BID # 01-220518

DISTRICT WIDE SEAL & STRIPE PROJECT – WEST SIDE
VICTOR ELEMENTARY SCHOOL DISTRICT
VICTORVILLE, CA

ADDENDUM – 03

PLANS & SPECIFICATIONS

DISCOVERY SCHOOL OF THE ARTS Total Capacity: 925

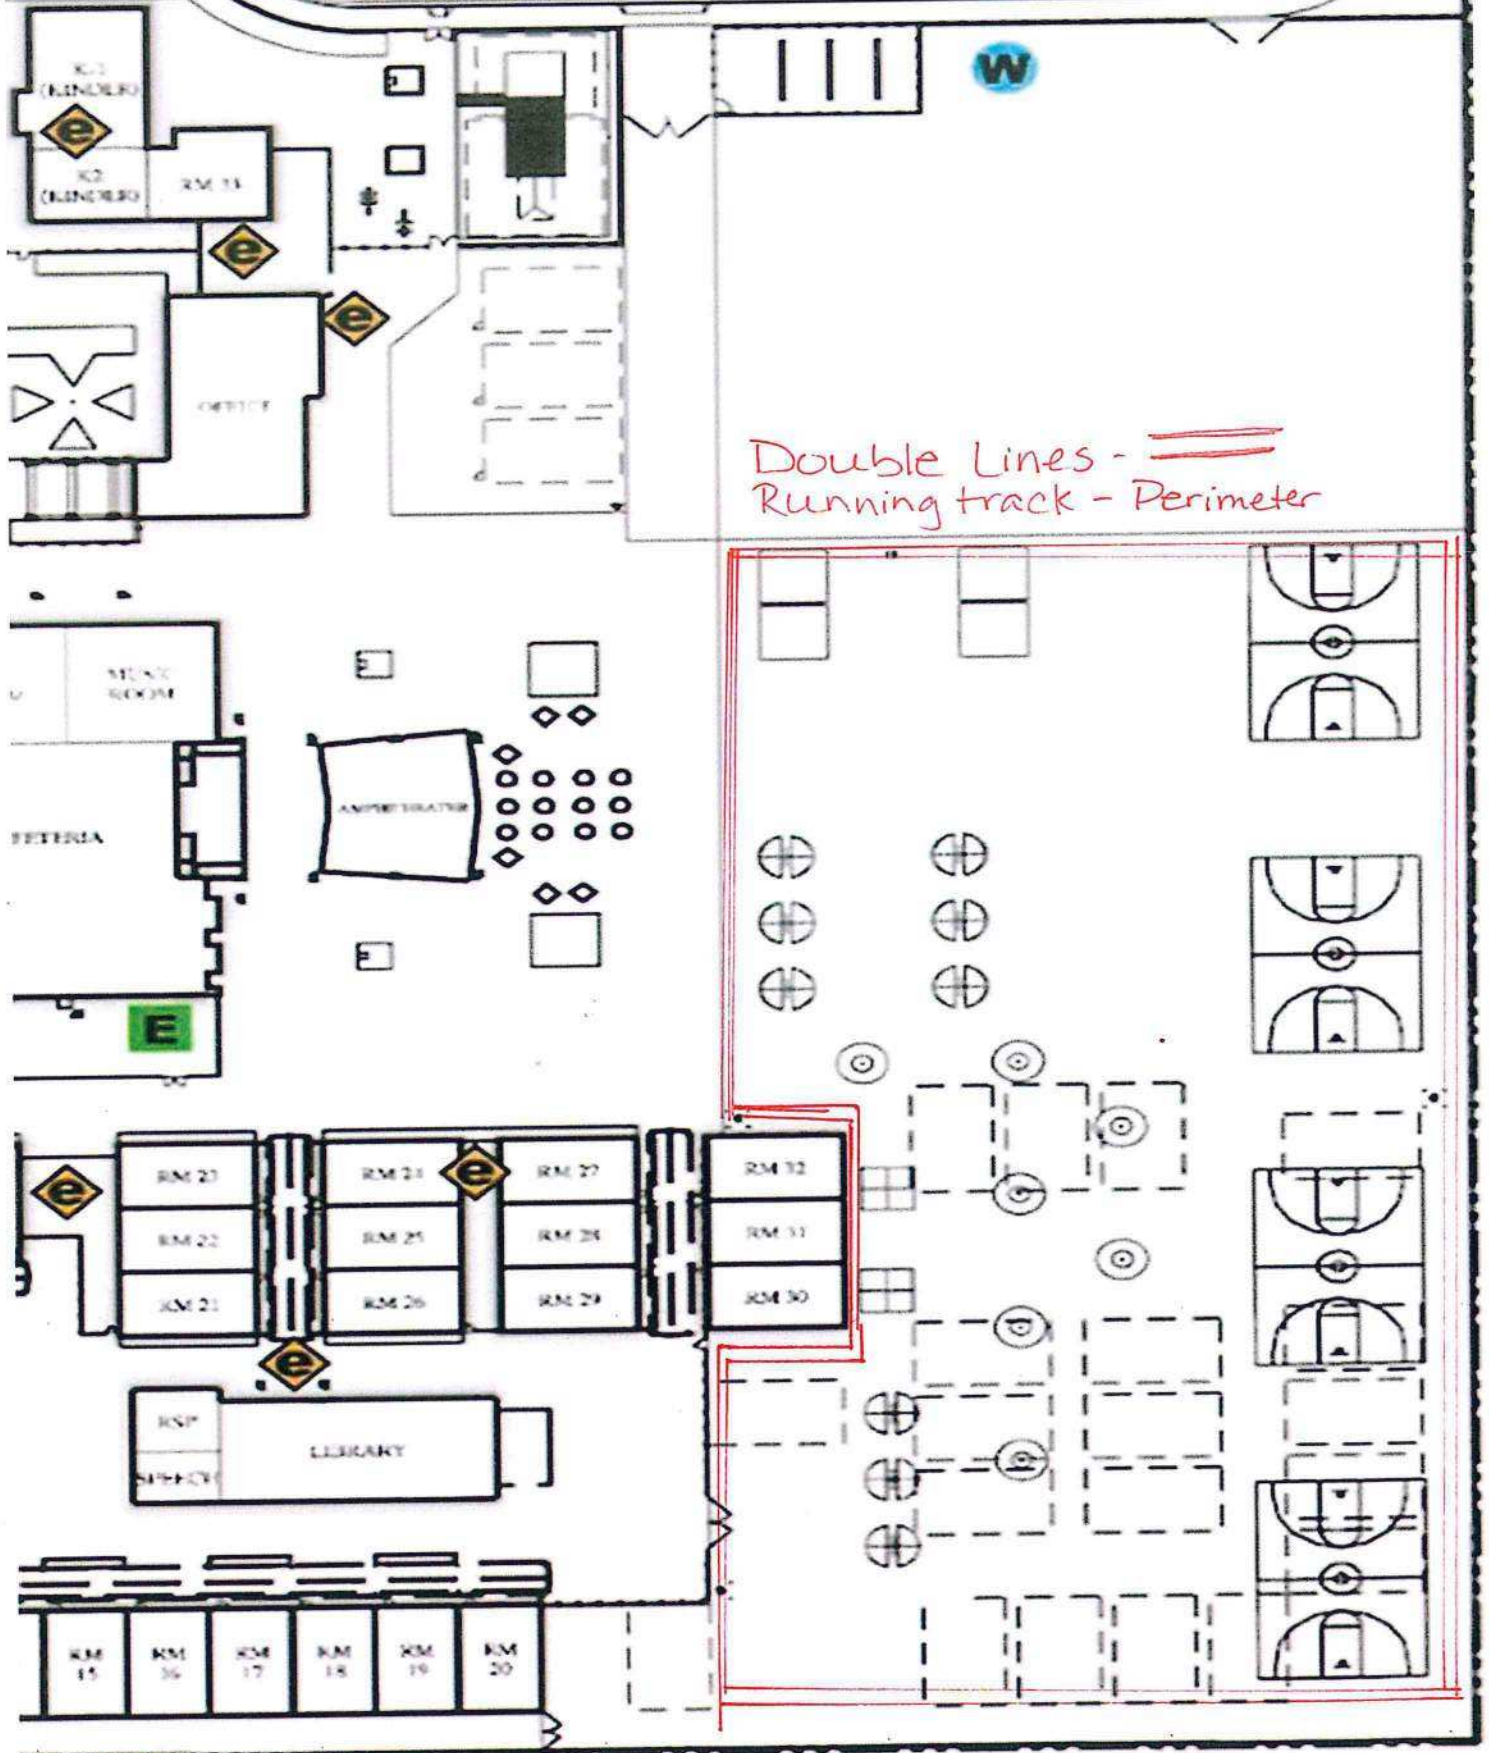
Special Conditions
 1. Additional striping to be included as shown as part of Sheet D-1.

LIBERTY ELEMENTARY SCHOOL

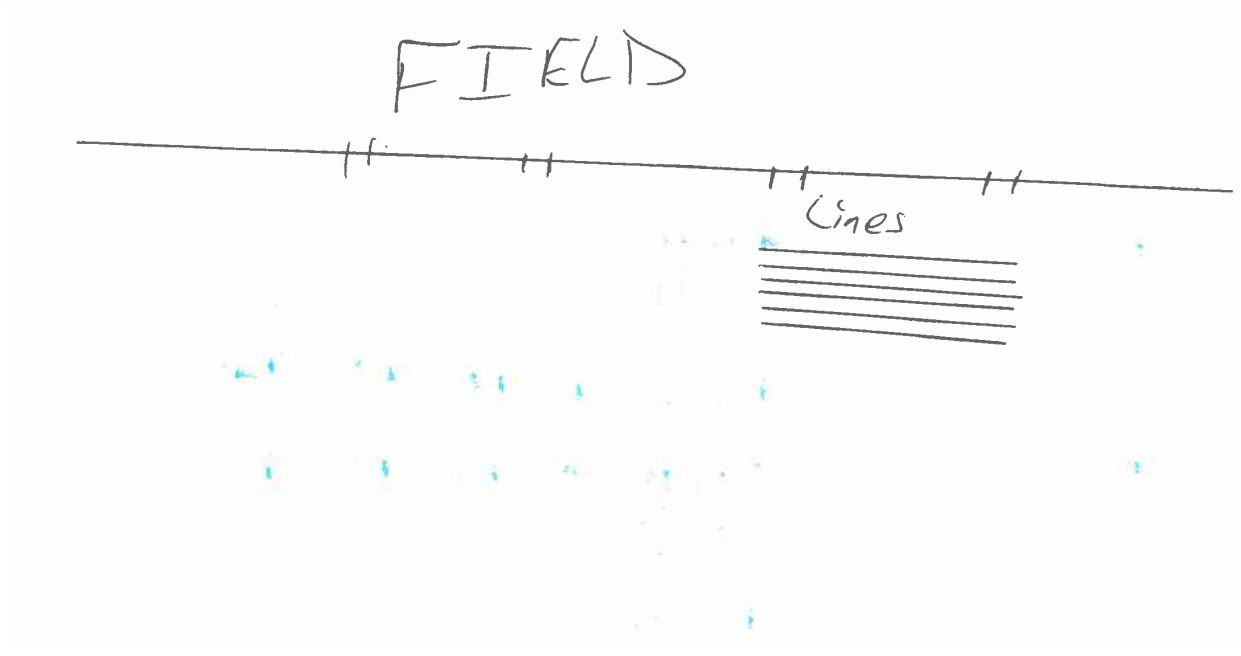
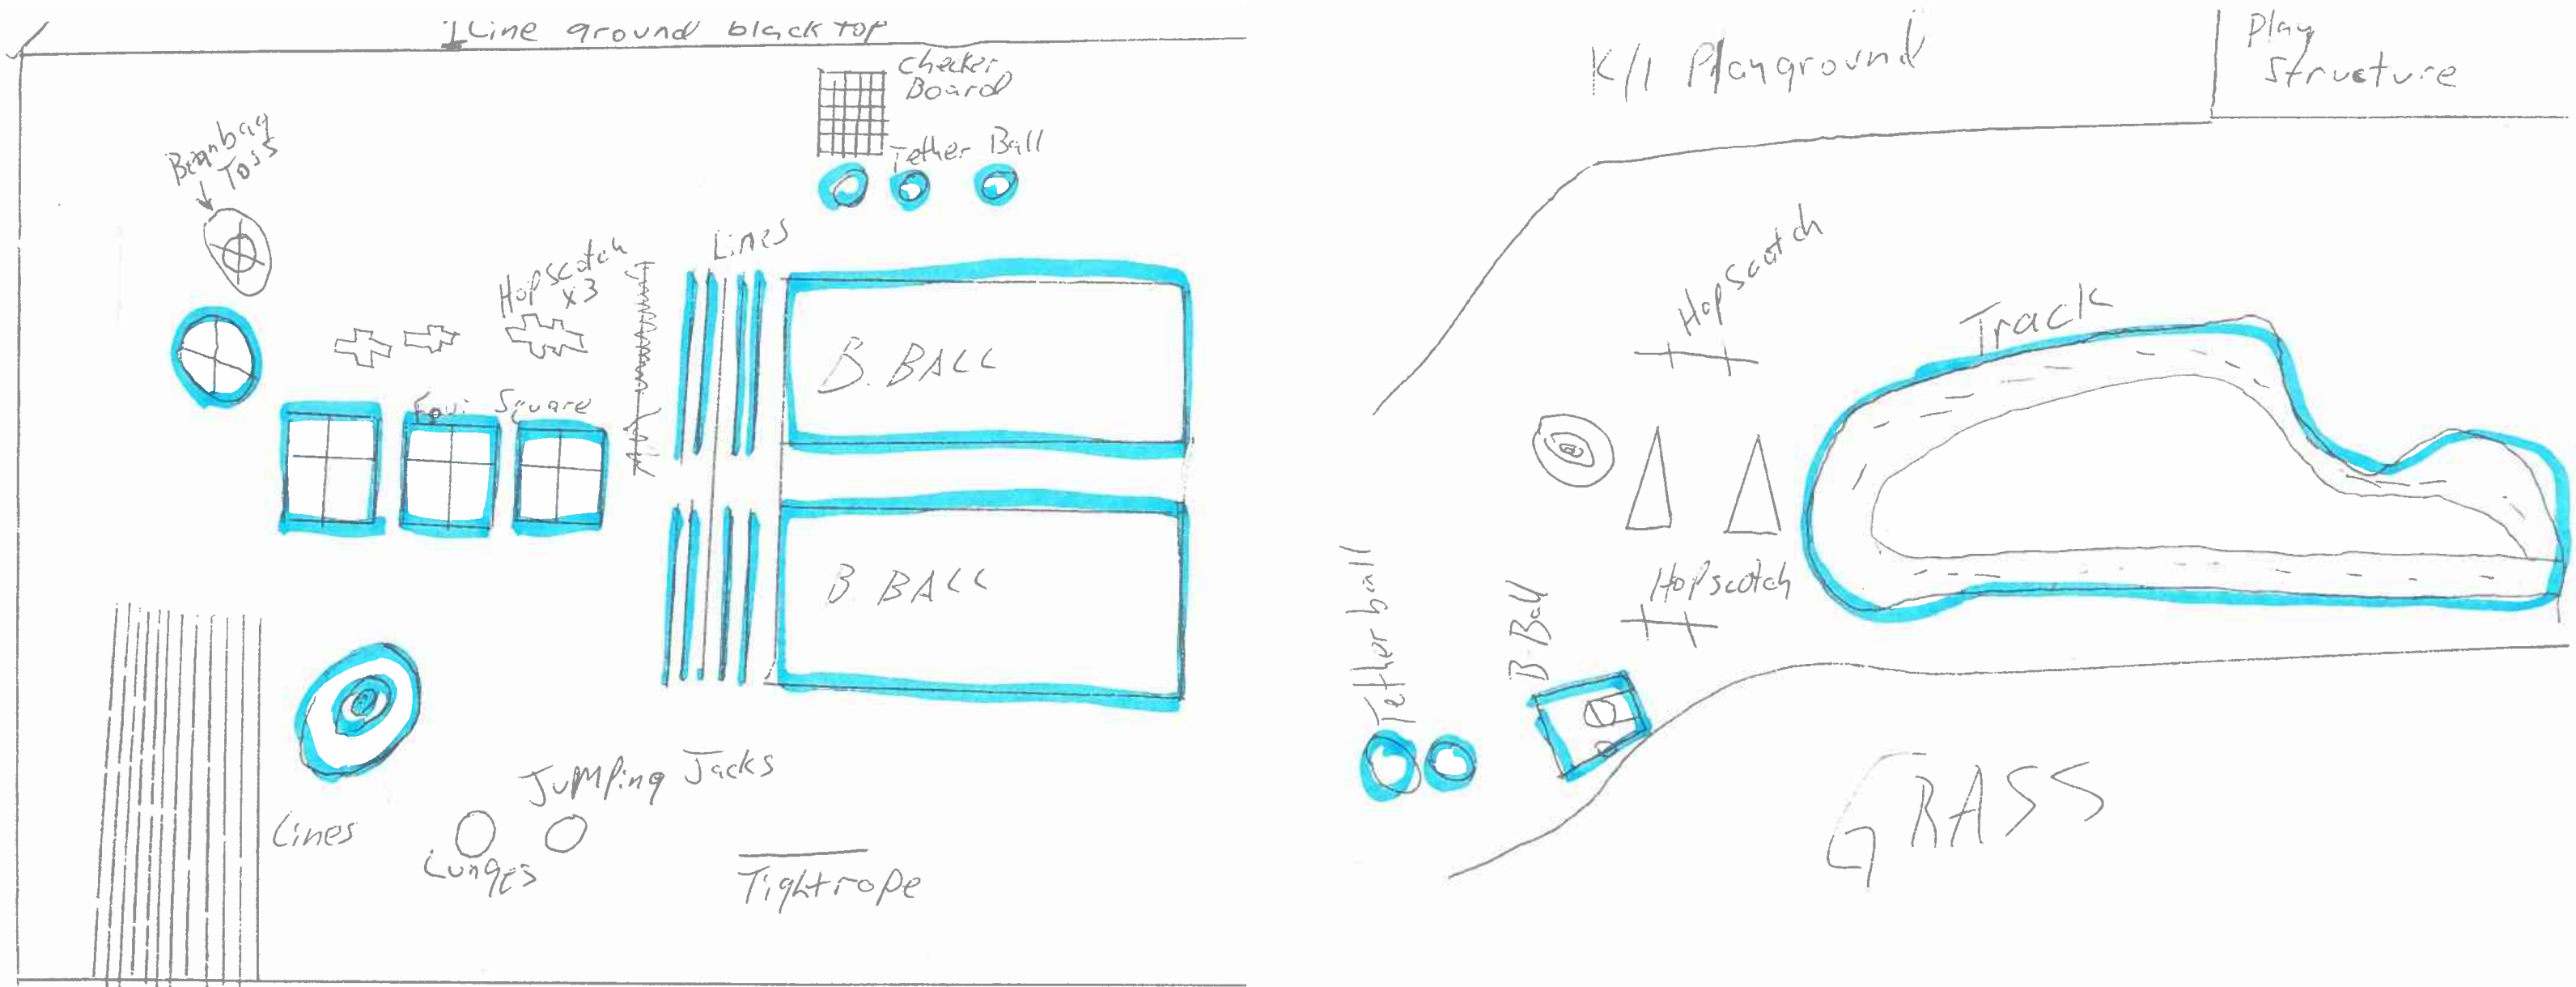
Special Conditions
 1. Contractor to provide additional striping as shown (existing striping highlighted in Blue) per Sheet L-1: Additional Striping Plan.

General Notes
 1. Existing striping shown in Blue, new striping to be per mark-ups.

SHEET P-1: ADDITIONAL STRIPING PLAN

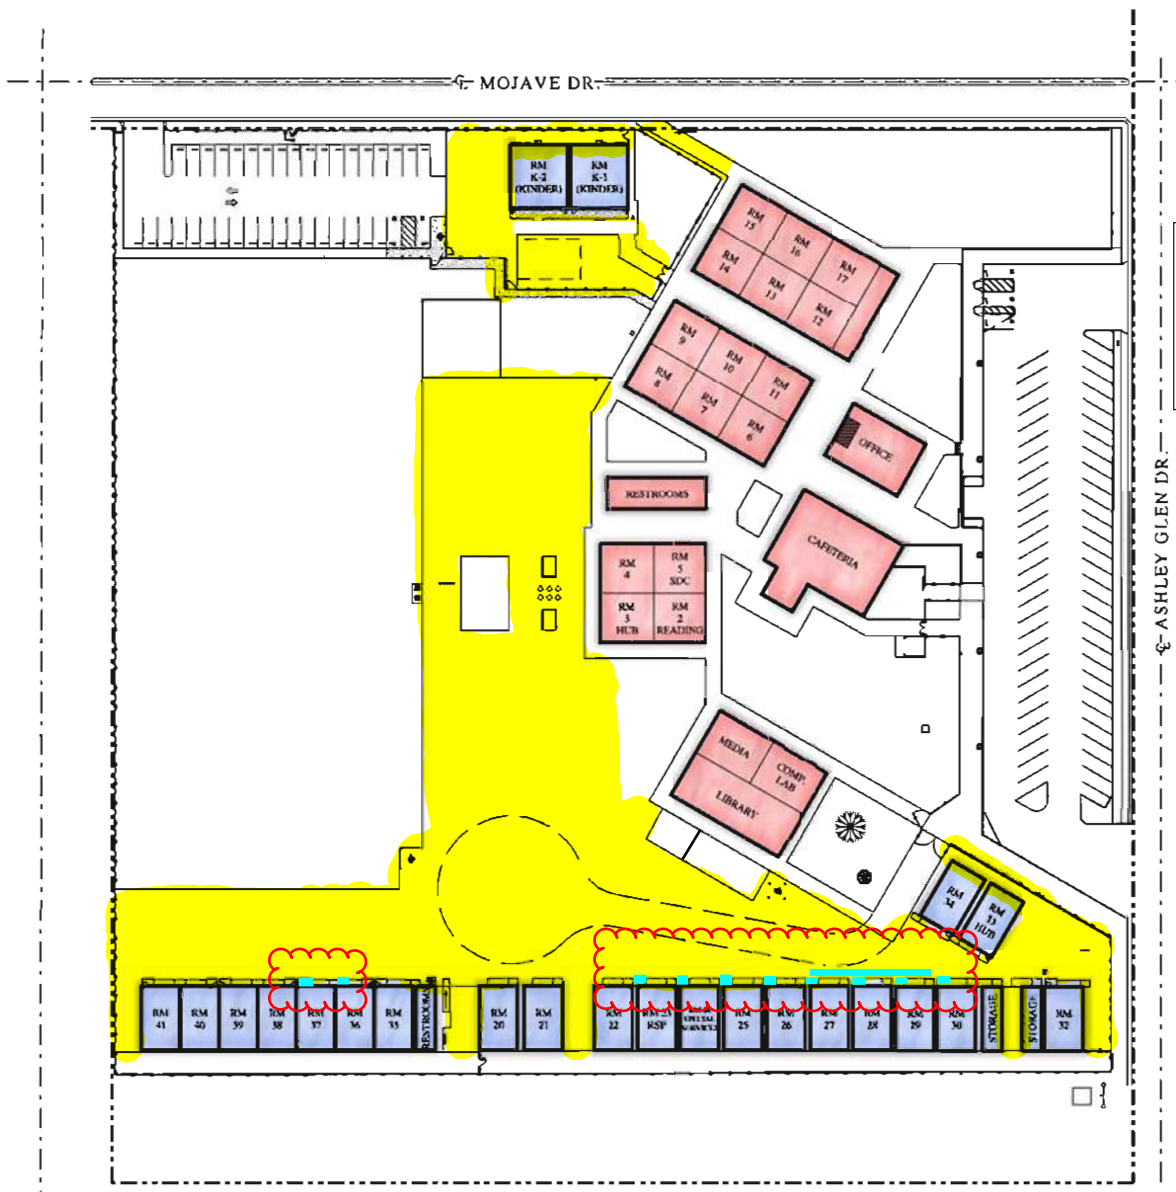
1. Contractor to provide an alternate to remove and replace 1500 SF with Asphalt, also provide a separate alternate to replace with concrete.
2. Contractor to provide additional striping as shown per Sheet P-1: Additional Striping Plan.

① Provide alternate for R & R
